#### REMARKS

Enclosures: Proposed corrections to Figs. 1 and 2

FIG. 1

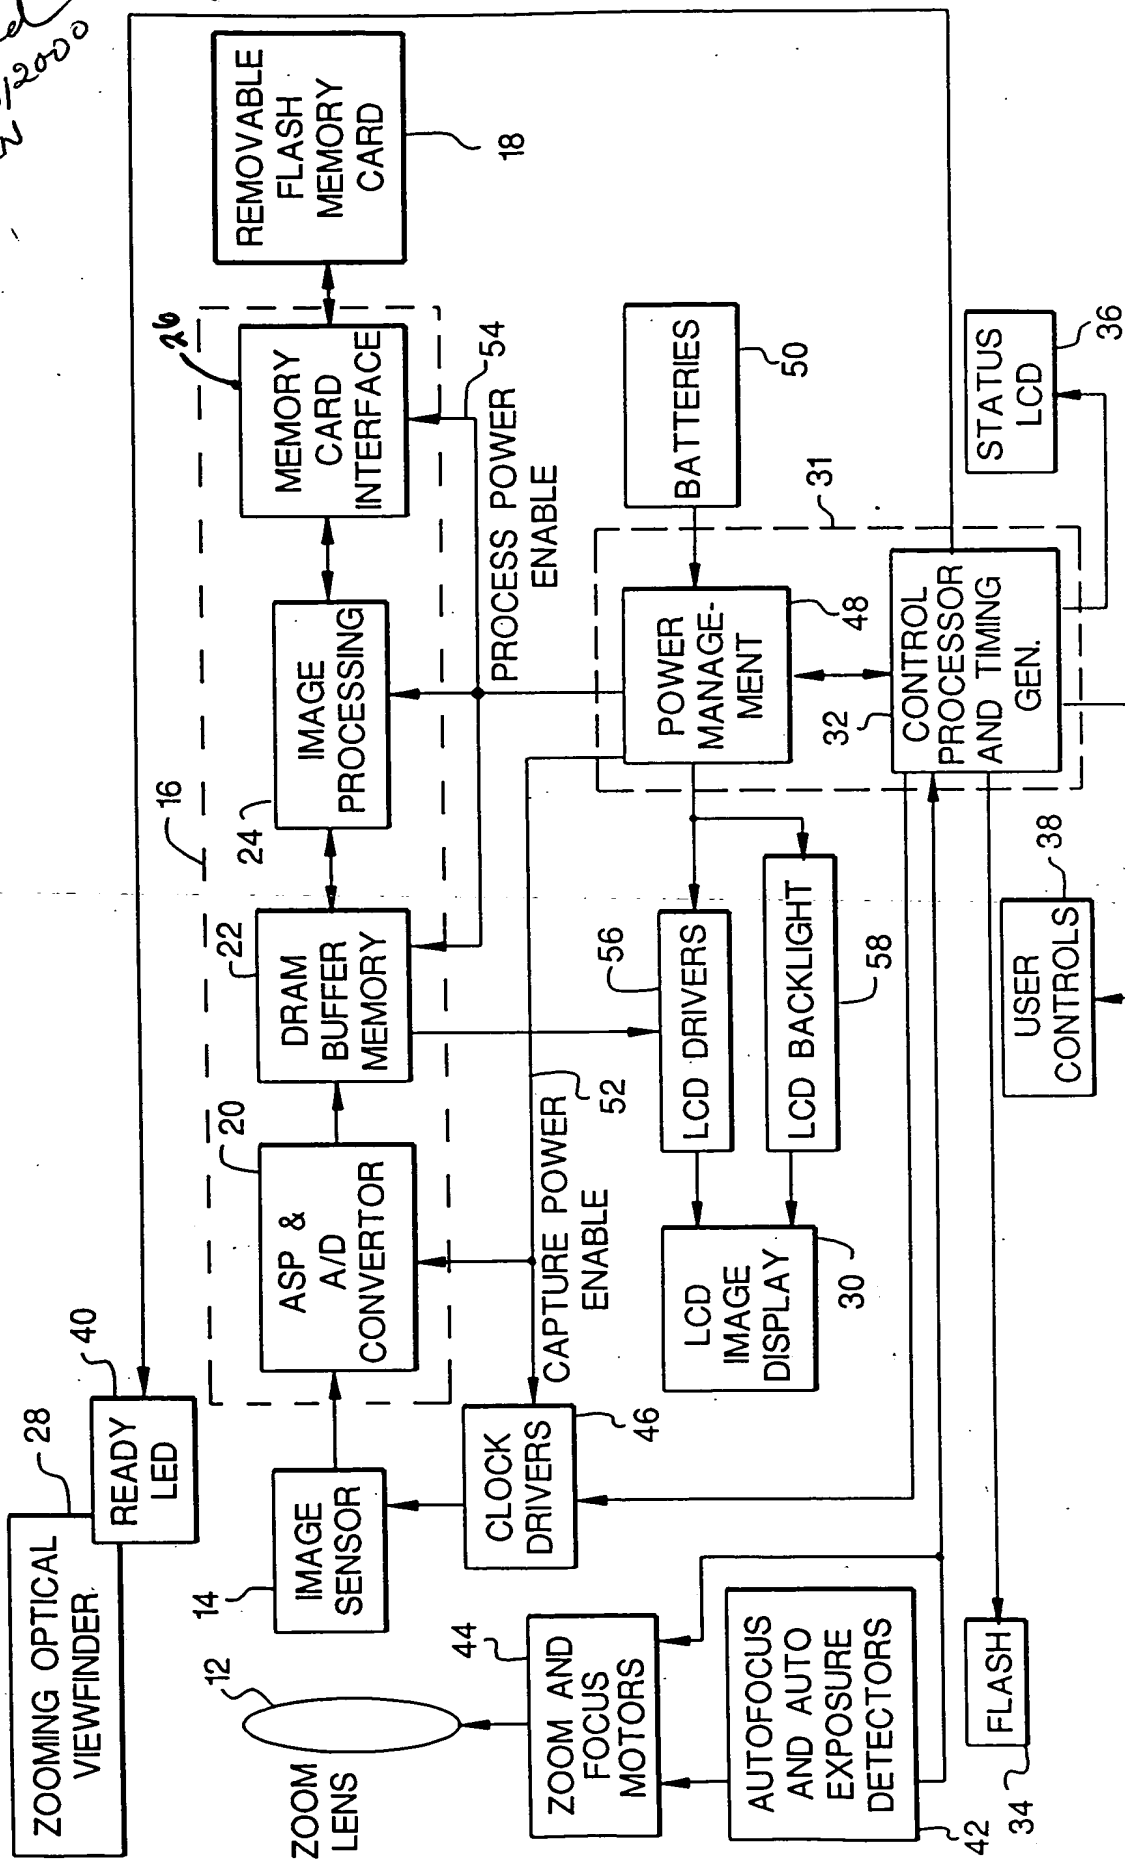
The drawings were objected to under 37 CFR 1.84(p)(5) because they fail to show element 26 in FIG. 1 and element 50 in FIG. 2C as described in the specification.

Subject to approval of the Examiner, the enclosed FIGS. 1 and 2C have been corrected so that elements 26 and 50 properly designate the corresponding parts. Accordingly, these changes should remove the Examiner's objections to FIGS. 1 and 2C. Applicants will submit corrected formal drawings upon an indication of allowable subject matter.
